United States Department of the Interior

PROPERTY: Zion-Olivet Presbyterian Church, 134 Cannon Street, Charleston, SC PROJECT NUMBER: 37481

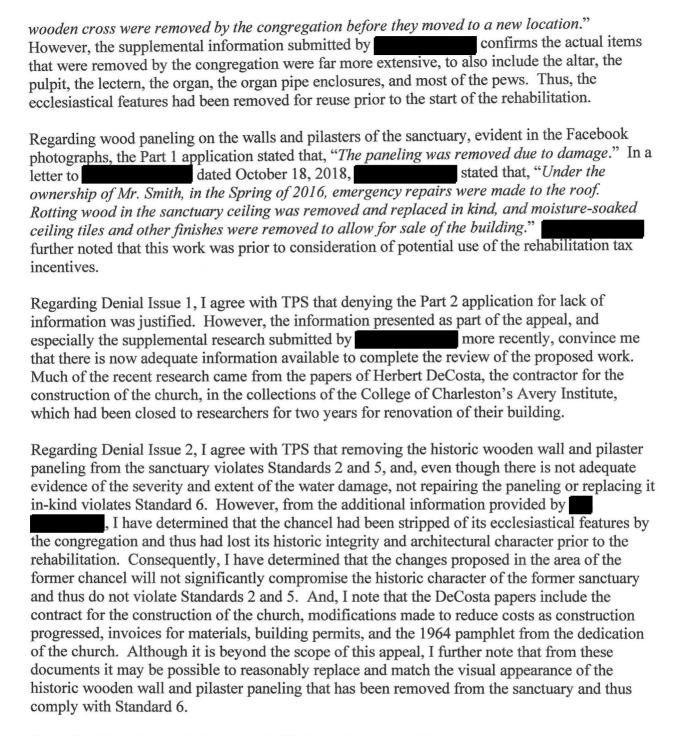
Typical of Modernist design, the sanctuary's interior was sparsely ornamented, but included carefully detailed finish materials on the walls and ceiling. A photograph from the dedication program shows that the chancel featured a pierced metal reredos behind the altar, flanked by wood pilasters and glazed-brick wall panels, and, on the right side, a raised platform for the organ console with an organ pipe enclosure above it, and, on the left side, a musician and choir gallery with an organ pipe enclosure above it. A pulpit and a lectern flanked the altar.

In my review, I discovered that the chancel features, visible in the 1964 dedication photograph, appear to have been in place as late as December 2015, from photographs of the space posted on the church's Facebook page. The only apparent change between the two photographs, taken more than fifty years apart, is that a large cross was hung on the pierced metal reredos. The only change to the chancel mentioned in the Part 1 application was that, "The pierced screen and
